Ref: P180403

RE: EdgeConneX Ireland Ltd., Retention & Completion of Amendments, Ballymaikaily, East of the Newcastle Road, (R120), Lucan, Co. Dublin Planning Reg. Ref. No. SD22A/0009

Further to the Clarification of Additional Information request in respect of the above development, as received from the Local Authority, dated 18th May 2022, we would respond as follows:-

Figure 1 Original Access locations

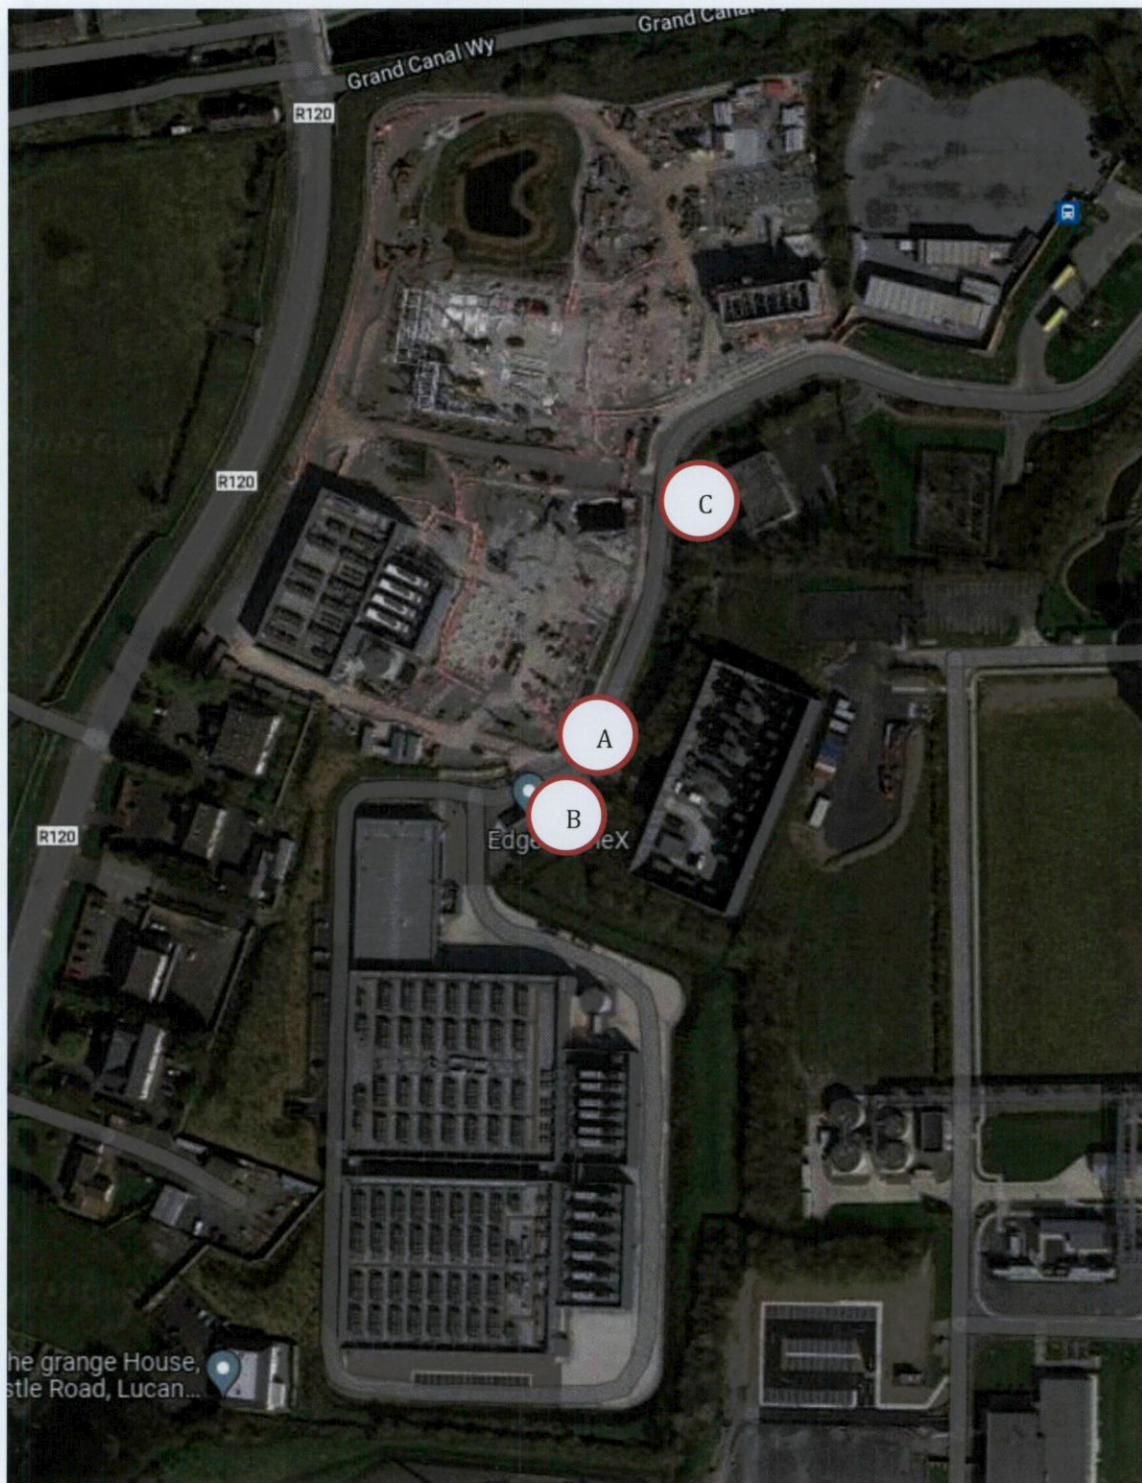
2. *The Roads Department is not satisfied with the information submitted regarding the internal road layout. Therefore, clarification of additional information is requested from the applicant on the following:*

- a. *The traffic layout under previously permitted permissions (both facilities) detailing how traffic moves within the site/was proposed to move within the site.*
- b. *A detailed note on each of the proposed changes (using clear references to Gate A, Gate B, Fence Removal, etc.)*
- c. *The proposed traffic layout.*
- d. *Detailed description is required outlining what arrangements are proposed not limited to but including: One-way/two-way systems, traffic light locations, proposed road markings, kerb radii, AutoTRAK swept path analysis.*
- e. *Explanatory note detailing the requirement to close Gates at A & B.*

It was originally anticipated that there would be multiple end users on site requiring secure access to each individual campus. This meant that Gate A, Gate B and Gate C would provide secure access independent of each other.

For the northern campus, two gates, Gate A and Gate C, were proposed. Internal circulation was via a one-way system. The Gate C would be the access point and Gate A would be exit point.

For the southern campus, there would be a single point of access/egress at Gate B.

This is illustrated in the figure below.

Figure 2 Primary Access Layout

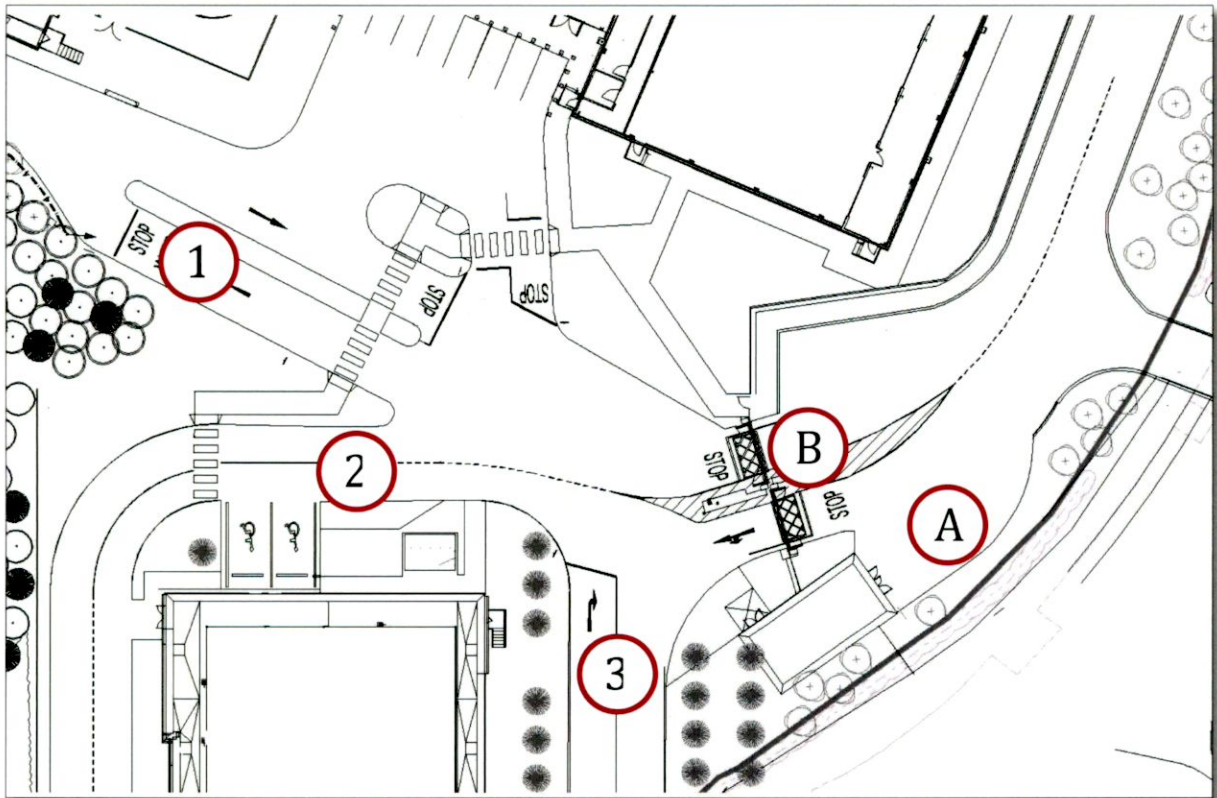
- c. Demonstrates ALL proposed road traffic movements within the site.*
- d. Demonstrates how traffic will flow safely and seamlessly in the busy zone west of the existing entry/exit gates.*

- f. Demonstrates how employees will travel to the car-park spaces situated in the northern section of the site.*
- g. Details emergency access arrangements (including AutoTRAK).*

As part of this application, Gate C will be reserved for emergency vehicle access and abnormal load access only.

Access No. A and Access B will be combined into a single access and will provide primary access to the entire campus as illustrated below.

The southern campus will have unrestricted circulation. The northern campus will have metered access, via a traffic signal system, to the docks/car parking spaces within the northern campus.

A summary of the primary access is outlined below:

- **A** – all vehicles enter the site via the security gate
- **B** – all vehicles leave the site via the security gate
- **1** – Vehicles traveling to the northern half of the campus do so via a metered system. The route to the northern half of the campus is narrow and it is not possible to have two-way traffic. This route involves a signalized system that will meter access to the access route. No vehicles will be allowed to enter the system unless they have a signal to proceed.
- **2/3** – Vehicles traveling to the southern half of the campus do so via Route 2 or 3.

The Gate C, not shown on the image above, will be used for abnormal load and emergency vehicle access only. Refer to the enclosed Transport Statement and associated drawings for further information.
